METROPOLITAN GOVERNMENT OF NASHVILLE AND DAVIDSON COUNTY

STAFF RECOMMENDATION
1107 Chapel Avenue
December 19, 2012

Application: New construction – accessory building and Setback reduction
District: Eastwood Neighborhood Conservation Zoning Overlay
Council District: 06
Map and Parcel Number: 08208029600
Applicant: EOA Architects
Project Lead: Robin Zeigler, robin.zeigler@nashville.gov

<p>Description of Project: The applicant proposes to install a two-phase modular classroom at the rear of the property.</p> <p>Recommendation Summary: Staff recommends approval of the proposed demolition of non-contributing outbuildings, construction of the modular building in two phases, and the requested setback reduction with the condition that the modular buildings only be in place for ten years. With that condition met, staff finds the application will meet the Eastwood Neighborhood Conservation Zoning Overlay design guidelines.</p>	<p>Attachments A: Photographs B: Public Comment C: Site Plan D: Elevations</p>
---	---

MODULAR CLASSROOM
FLOOR PLAN

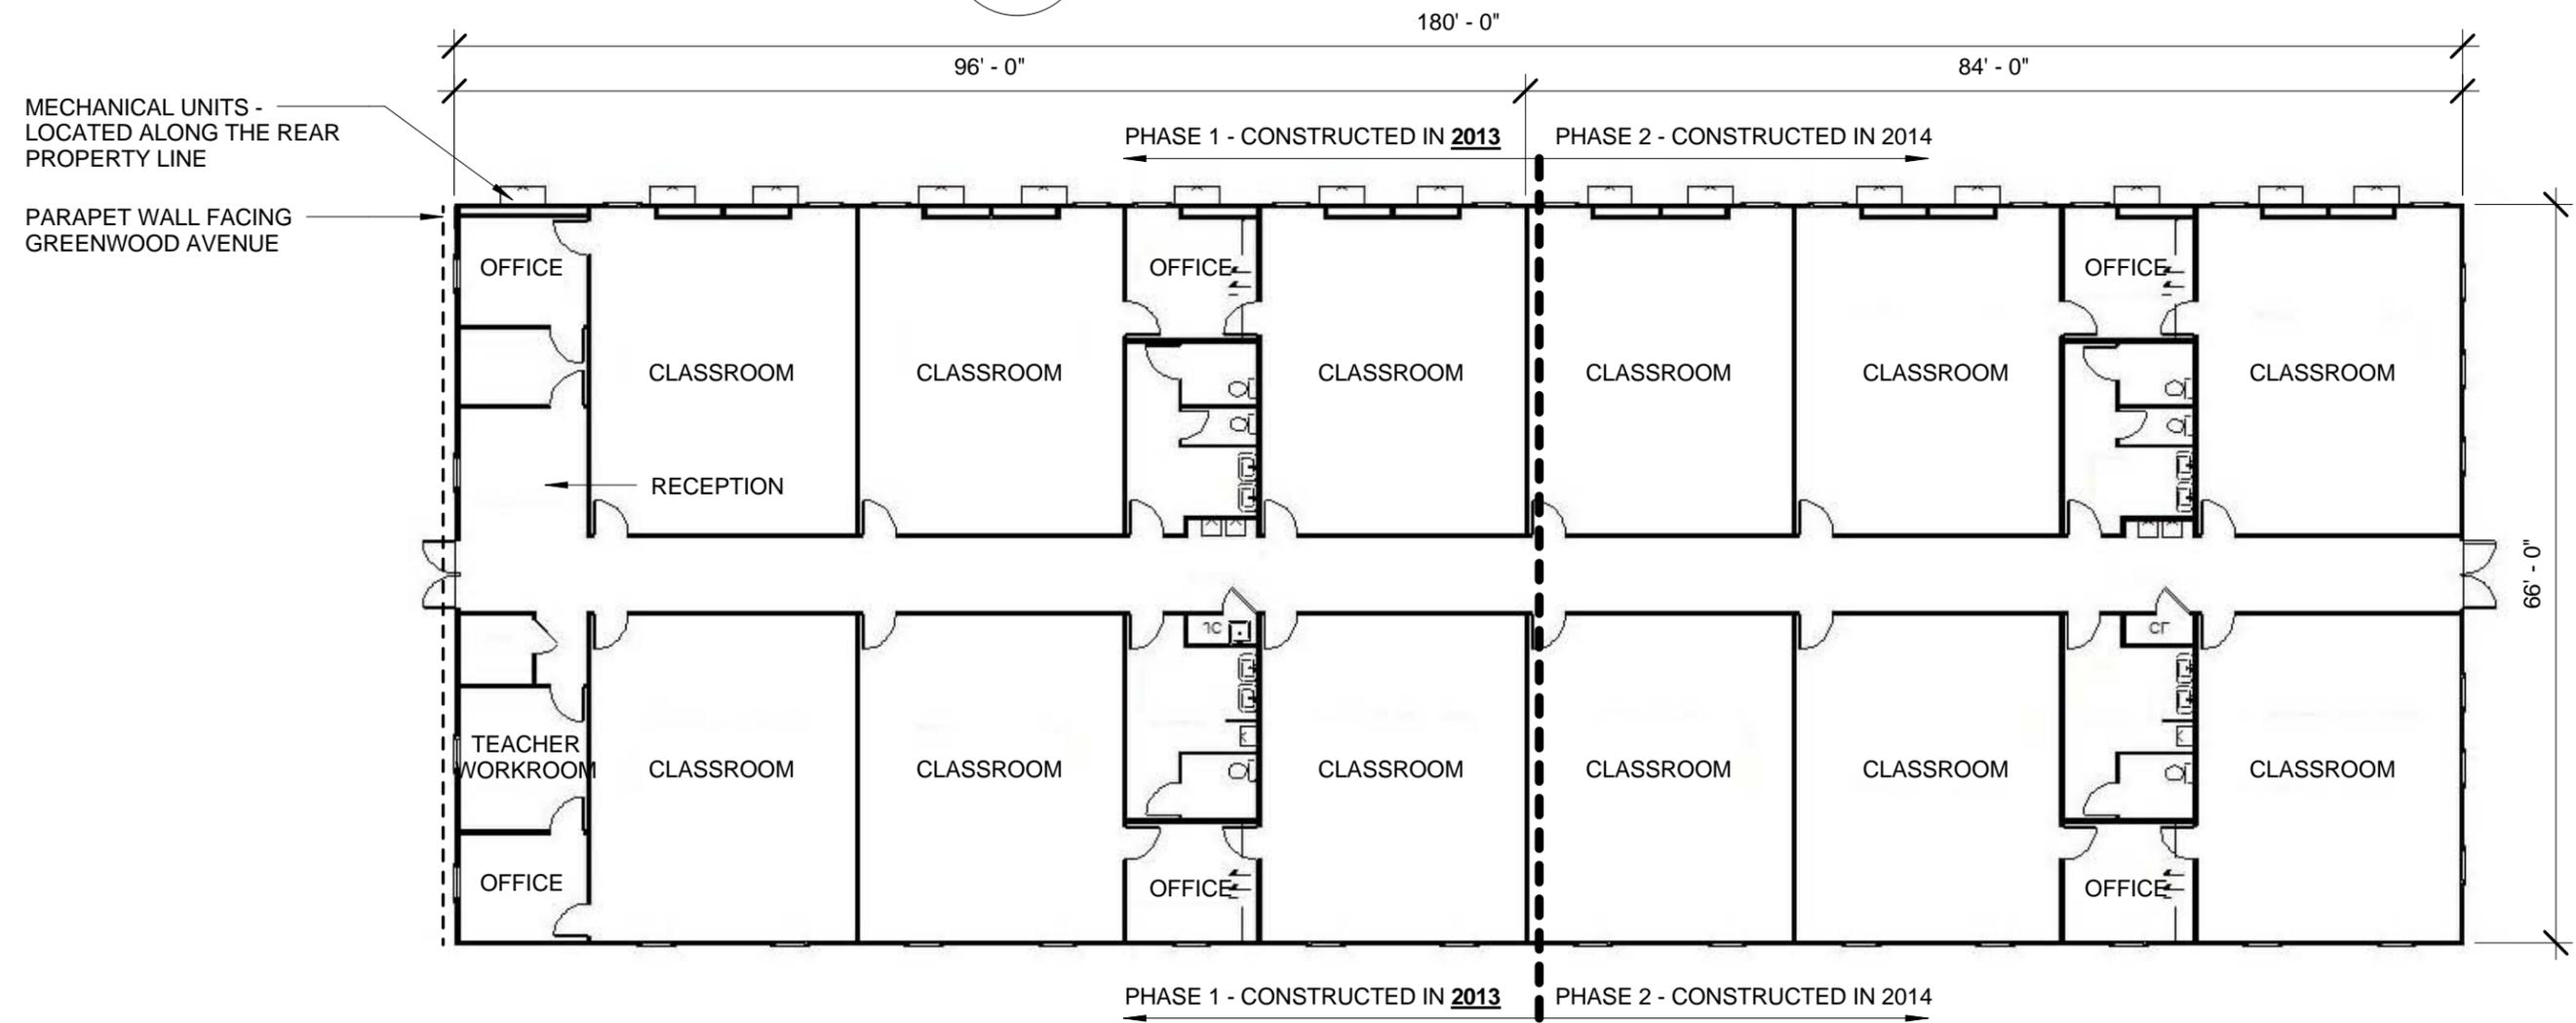
The accessory buildings do not date to the period of significance (1875-1930) and are not character defining features of the property or the district; therefore, staff finds demolition to be appropriate. Demolition meets guideline III.B.2.b.

Typically outbuildings are located towards the rear of a lot and close to property lines. This building meets section h.2. as it is located in the rear corner. At its closest point, the modular building is approximately ninety feet (90') from the historic building. It does not meet the bulk zoning requirements for setbacks; however, the proposed setbacks were approved by the Board of Zoning Adjustment when the applicant made several requests for alterations to the requirements necessary to use the property as a middle school. The MHZC still has the ability to set the setback requirements for this property. The applicant proposes a twelve foot (12') setback from the interior lot line and a thirty-two foot (32') setback from the rear property line. Because outbuildings were typically at the rear of the lot, because there is no rear alley, and because this location will have the least visible impact as seen from the street, Staff finds the proposed setbacks to meet section II.B.1.c.

The one-story modular building will be approximately eleven feet (11') tall from finished floor which is far below the height of the two-story existing structure. The footprint is 11,880 square feet, once both phases are completed, which is subordinate to the twenty-eight thousand square feet (28,000 sq ft) of the historic building.

Staff recommends approval of the proposed demolition of non-contributing outbuildings, construction of the modular building in two phases, and the requested setback reduction with the condition that the modular buildings only be in place for ten years. With that condition met, staff finds that the project meets the Eastwood Neighborhood Conservation Zoning Overlay design guidelines.

MODULAR CLASSROOM ELEVATIONS

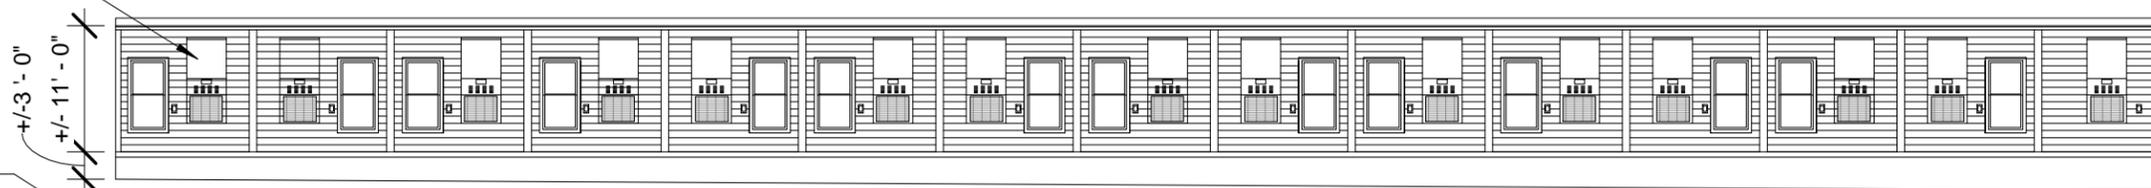
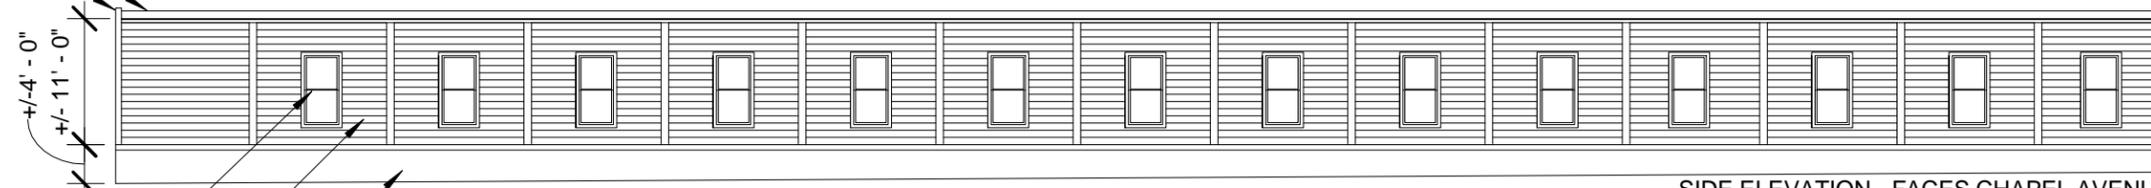
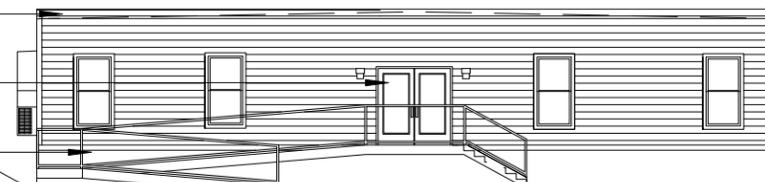
The foundation shall be textured fiber-cement panels. The cladding shall be smooth lap siding with a maximum of a five-inch (5") reveal, h-molding trim where necessary and "low profile outside corner" trim. The roof will be black EPDM but be hidden by a parapet wall on the Greenwood Avenue facing elevation. Entry stairs and ramp will be pressure treated wood. The windows are double-hung aluminum sashes without muntins/grids. Doors shall also be aluminum.

The roof is a low-slope but will be hidden by a parapet wall on the Greenwood Avenue elevation. Flat roofs or parapet roofs are appropriate as they are found on historic institutional and educational buildings in the overlay. The project meets section II.B.1.e. and h.

The windows are evenly spaced with no more than eight feet (8') between the majority of the windows. The proportion is twice as tall as they are wide with four inch (4") casings. Both the rhythm of openings and the window proportions are appropriate and meet design guideline II.B.1.g and h.
